# Comments on Maintenance Item 0344: IEEE Std 802.1CB, IP stream recognition, and the R-tag

cb-finn-maintenance-item-0344-1122-v01

Figure 6-5—Stream functions in a relay system (three views of same system)

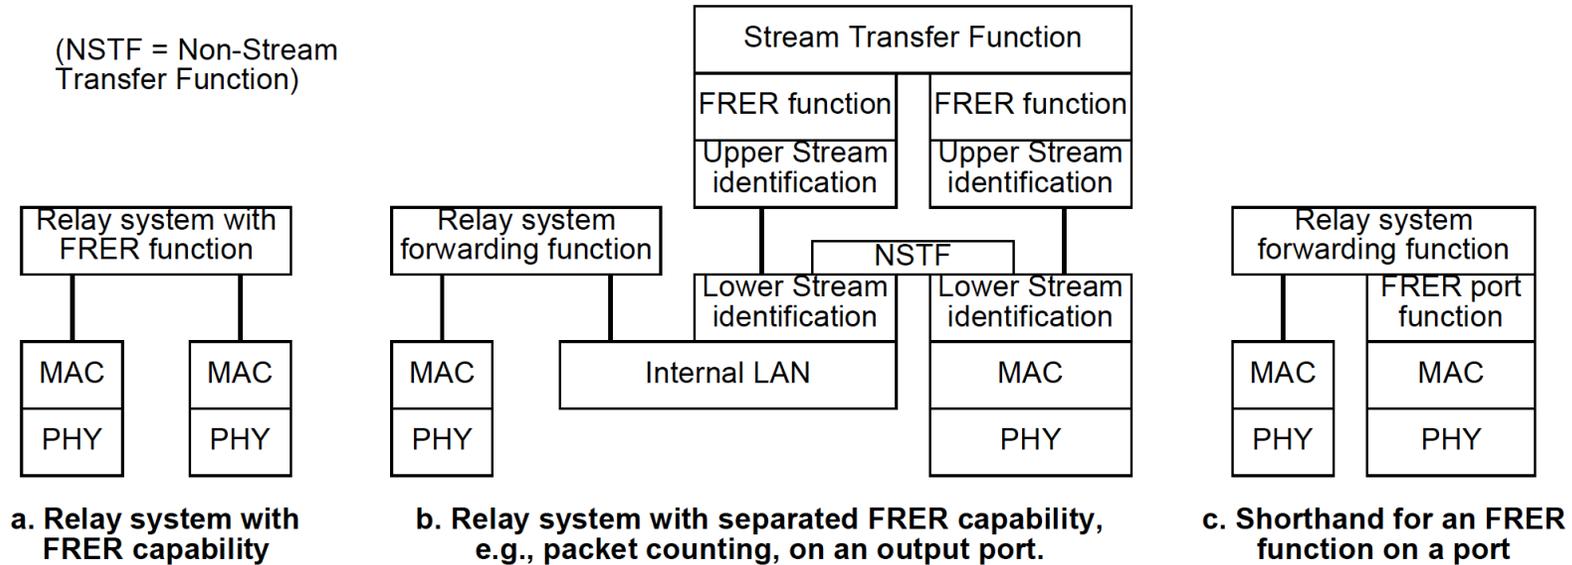
**Problem:** The **R-tag** is processed in “FRER in(out)-facing functions”. The **IP 5-tuple** is recognized in “Lower Stream identification”.

In general, Clause 6.7 **IP stream identification is a layer violation**, and **cannot be done cleanly** by a layer-2 bridge. All you can do is have a list of lower-layer protocols that you can skip over. IEEE Std 802.1CBdb mask-and-match had a similar issue with the Q-tag. We solved this by saying that mask-and-match is based on the ISS, and the other methods on the EISS.

IP stream identification is, potentially, used in place of the priority value in the VLAN tag. It is used, potentially, at every hop. If used this way, there possibly more tags to skip over (e.g., a Q-in-Q provider bridge might peek at the IP header to spot VoIP). This makes the CBdb solution impractical; one size does not fit all.

If the IP stream identification function is tied, via the `stream_handle` parameter, to a sequence decode function (7.6), then IP stream identification functions only if the appropriate sequence encode/decode format is present. Otherwise, IP stream identification functions only if the IP protocol identifier immediately follows the (optional) VLAN tag.
